**STAFF RECOMMENDATION**

**1051 Petway Avenue**

**March 17, 2021**

**Application:** New Construction—Addition

① FRONT ELEVATION  
1/4" = 1'-0"

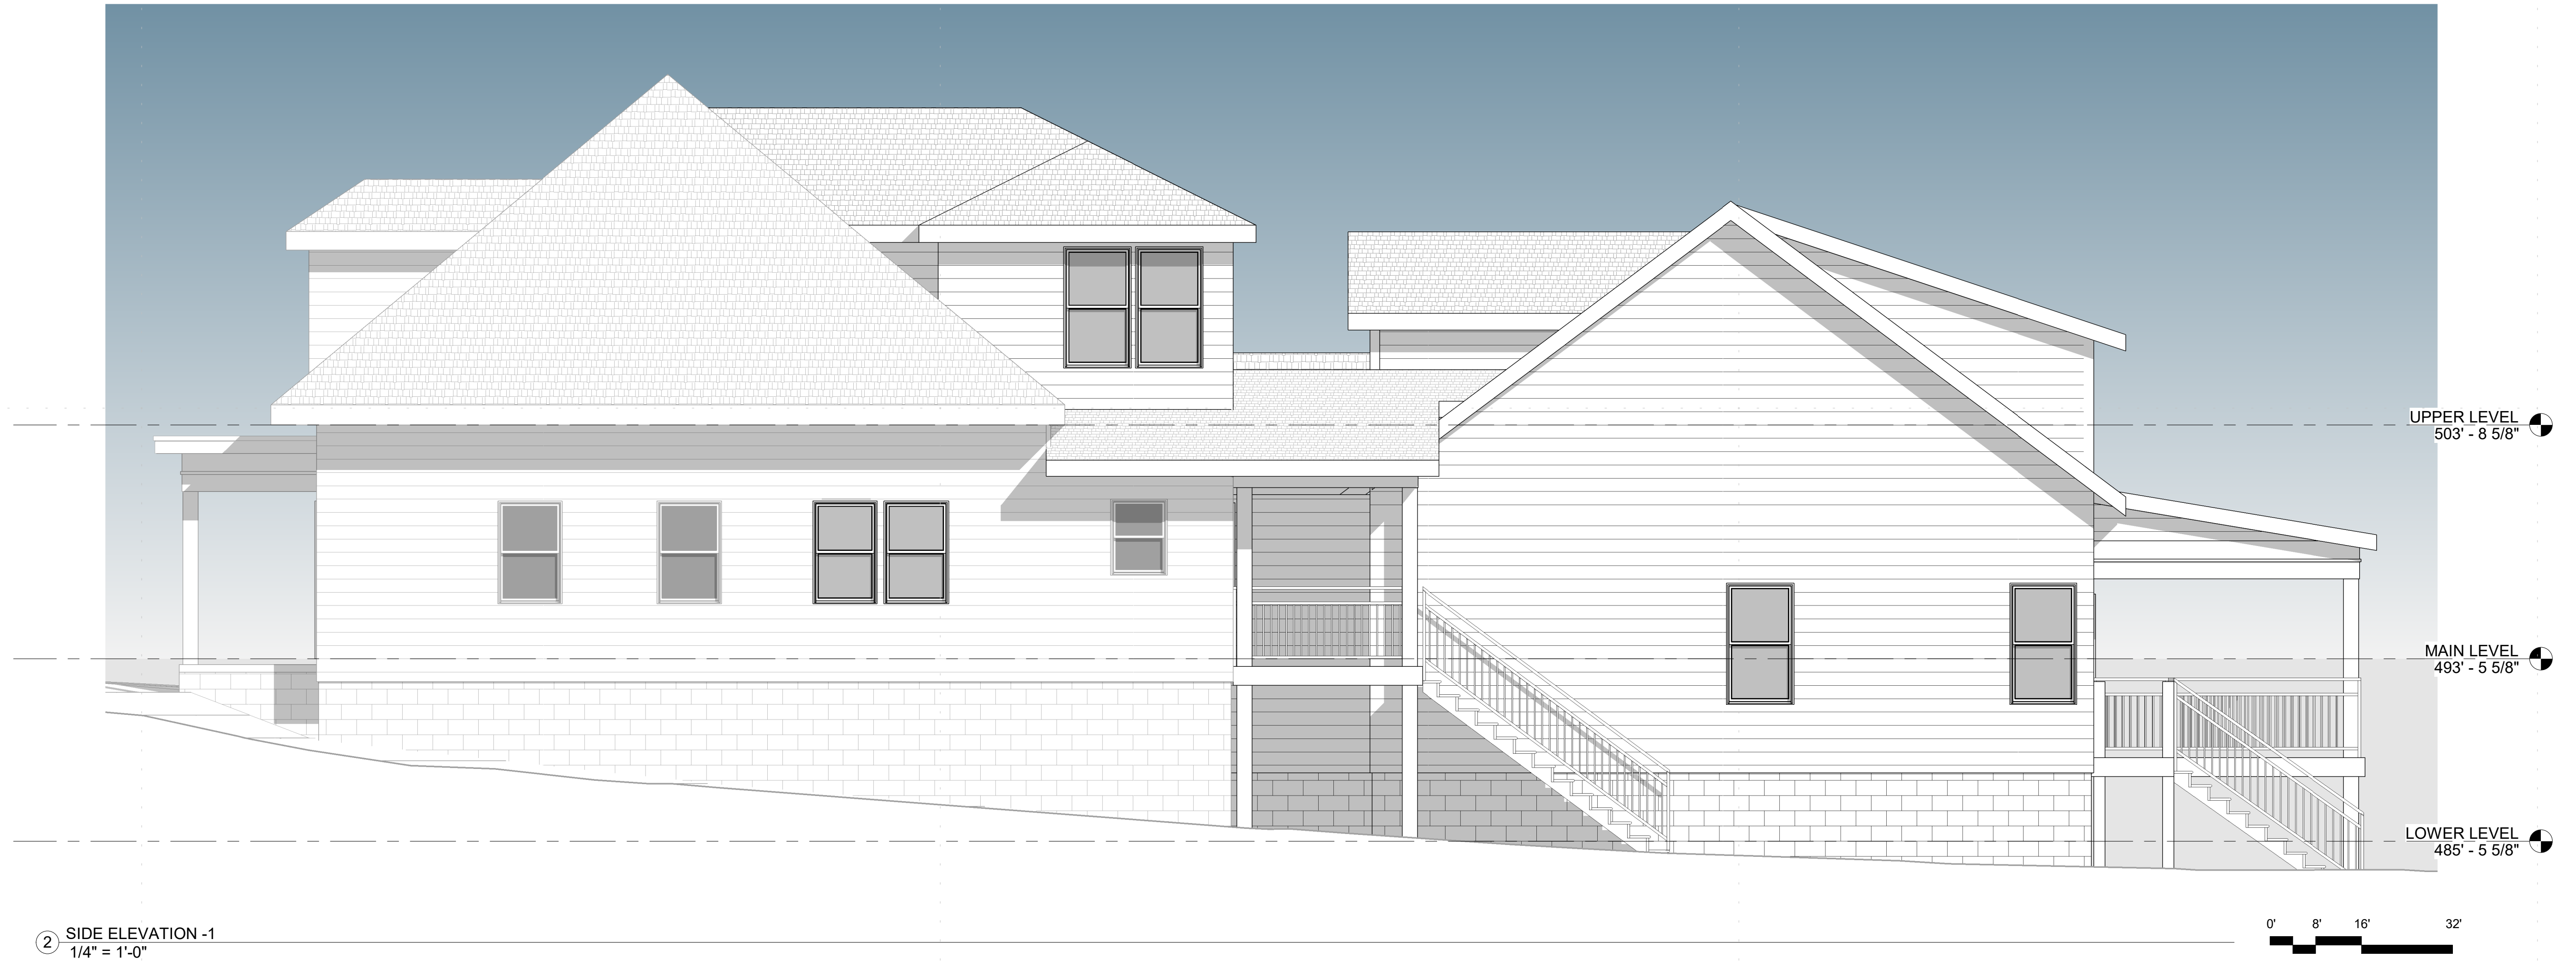
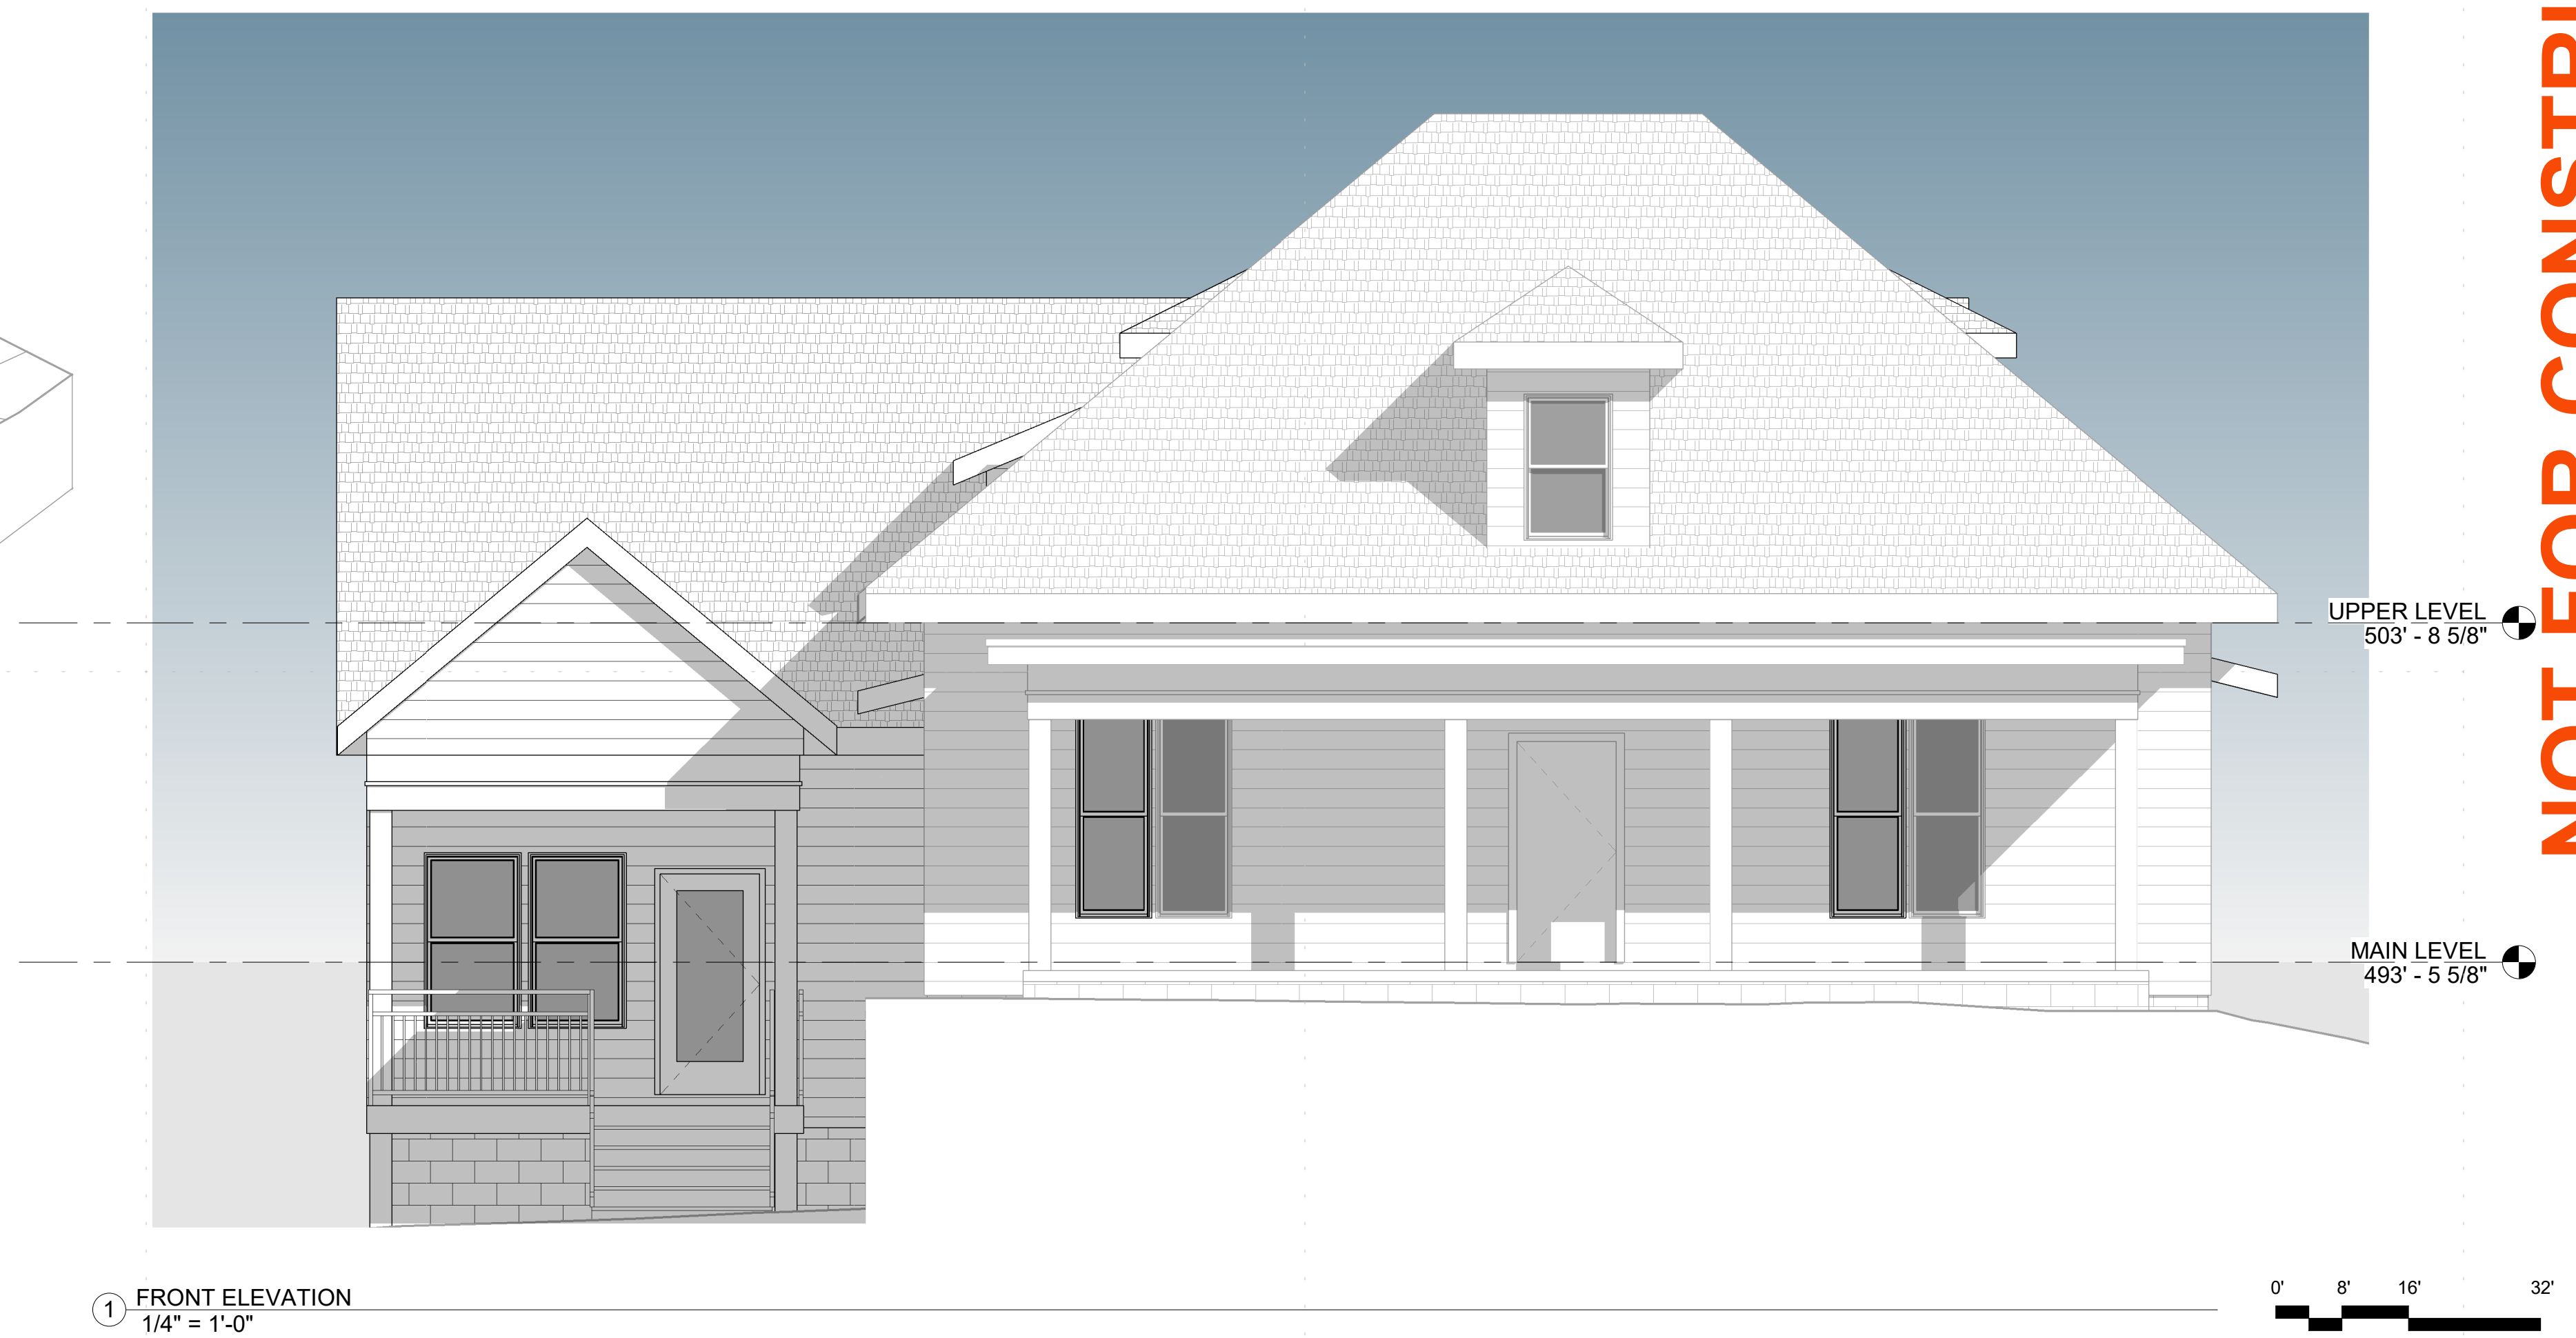
Roof form: The historic house has a hipped roof with an 10/12 pitch. The addition ties into the historic house's roof with a hipped dormer that is inset at least 2' from the side walls of the house. The main form of the addition is a side gable with a 10/12 pitch. The new front porch will have a flat roof, mimicking the historic porch roof. The secondary entrance on the wider portion of the addition has a 10/12 gable. The rear addition has additional gabled and shed roof forms that will not be highly visible from the street. Staff finds that these roof forms are compatible with the historic house.

Proportion and Rhythm of Openings: As mentioned under "Partial Demolition," many of the window and door openings will be altered, which is appropriate because the existing windows and doors openings have been altered. In general, many single openings will become paired openings. The fenestration pattern on the historic house and the proposed addition meets the design guidelines. They are all generally twice as tall as they are wide, thereby meeting the historic proportions of openings. There are no large expanses of wall space without a window or door opening.

Staff finds that the proposed roof forms meet Sections II.B.1.e. and II.B.2. of the design guidelines.

Staff finds the project's proportion and rhythm of openings to meet Sections II.B.1.g. and II.B.2. of the design guidelines.
